Access Compliance Report

Public Rights-of-Way

(Curb Ramps)

Intersection ID: 46304	Main Street: AUGUSTINE_WY	Cross Street: MERMANS_RD	Location: NW
ADA ID: 9E8D30FB2840	Ramp Type: PerpDiag	Initial Pass/Fail: Fail	Overall Compliance: No
		Severity Score: 22.5

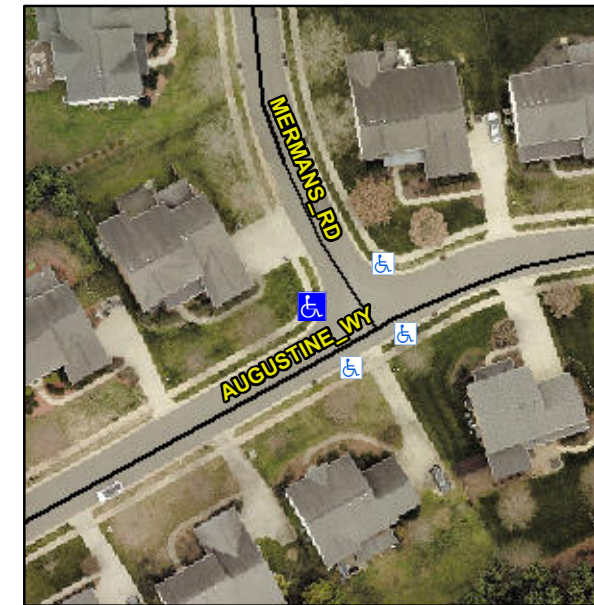
Not Found, R304.5.1, R304.2.2, R304.5.3

Compliance	Description	Data	Compliance	Description	Data
N/A	Ramp Length (in)	46.0	No	Ramp Slope (%)	8.6
No	Ramp Width (in)	40.0	No	Ramp XSlope (%)	2.5
N/A	Flare Type LT	N/A	N/A	Flare Type RT	N/A
N/A	Flare Slope LT (%)	N/A	N/A	Flare Slope RT (%)	N/A
N/A	Flare Traversable LT?	N/A	N/A	Flare Traversable RT?	N/A
N/A	Landing Length (in)	N/A	N/A	DWS Provided?	N/A
N/A	Landing Width (in)	N/A	N/A	DWS Contrast?	N/A
N/A	Landing Slope (%)	N/A	N/A	DWS Length (in)	N/A
N/A	Landing X Slope (%)	N/A	N/A	DWS Full Width?	N/A
N/A	Landing Curb? (Y/N)	N/A	N/A	DWS Offset (in)	N/A
N/A	Shared Landing?	N/A			
N/A	Gutter Ponding?	N/A	N/A	Gutter Slope (%)	N/A
N/A	Gutter Lip Ht (in)	N/A	N/A	Gutter X Slope (%)	N/A
N/A	Painted X Walk1?	No	N/A	Painted X Walk2?	No
	X Walk 1 Direction	To S		X Walk 2 Direction	To E
N/A	X Walk 1 Width (in)	N/A	N/A	X Walk 2 Width (in)	N/A
	X Walk 1 Slope (%)	7.2		X Walk 2 Slope (%)	4.3
	X Walk 1 X Slope (%)	1.7		X Walk 2 X Slope (%)	6.6

Remove & Replace Curb Ramp With Two New Directional Ramps or Equivalent.
